Access Compliance Report

Public Rights-of-Way

Intersection ID: 31292	Main Street: DEERTON_RD	Cross Street: MUNSING_DR	Location: W
ADA ID: 4B1EE873E8D1	Ramp Type: PerpDiag	Initial Pass/Fail: Fail	Overall Compliance: No
Severity Score: 22.5			
Codes/Mitigation Info/Possible Solution		Field Measurements/Component Compliance

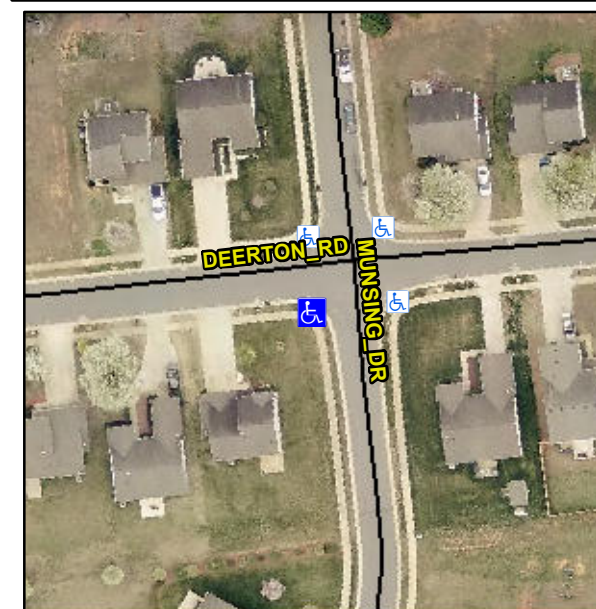
Not Found, R304.5.1, R304.2.2, R304.5.3

Compliance	Description	Data	Compliance	Description	Data
N/A	Ramp Length (in)	46.5	No	Ramp Slope (%)	8.4
No	Ramp Width (in)	40.5	No	Ramp XSlope (%)	4.8
N/A	Flare Type LT	N/A	N/A	Flare Type RT	N/A
N/A	Flare Slope LT (%)	N/A	N/A	Flare Slope RT (%)	N/A
N/A	Flare Traversable LT?	N/A	N/A	Flare Traversable RT?	N/A
N/A	Landing Length (in)	N/A	N/A	DWS Provided?	N/A
N/A	Landing Width (in)	N/A	N/A	DWS Contrast?	N/A
N/A	Landing Slope (%)	N/A	N/A	DWS Length (in)	N/A
N/A	Landing X Slope (%)	N/A	N/A	DWS Full Width?	N/A
N/A	Landing Curb? (Y/N)	N/A	N/A	DWS Offset (in)	N/A
N/A	Shared Landing?	N/A			
N/A	Gutter Ponding?	N/A	N/A	Gutter Slope (%)	N/A
N/A	Gutter Lip Ht (in)	N/A	N/A	Gutter X Slope (%)	N/A
N/A	Painted X Walk1?	No	N/A	Painted X Walk2?	No
	X Walk 1 Direction	To E		X Walk 2 Direction	To N
N/A	X Walk 1 Width (in)	N/A	N/A	X Walk 2 Width (in)	N/A
	X Walk 1 Slope (%)	1.5		X Walk 2 Slope (%)	6.4
	X Walk 1 X Slope (%)	4.4		X Walk 2 X Slope (%)	2.8

Remove & Replace Curb Ramp With Two New Directional Ramps or Equivalent.
